Refinements to the Mouse Vascular Access Button™

On October 22, 2019 we introduced an improved design of the magnetic one channel mouse Vascular Access Buttons and the protective aluminum caps. Part numbers and prices did not change. No changes to surgical procedures should be required.

BUTTON

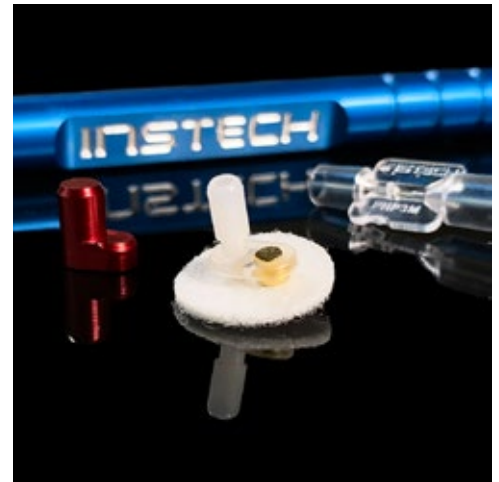
Old
.30 grams

New
.27 grams

smaller flange

gold plated magnet for durability

Base area, around which skin is closed, reduced by 40%
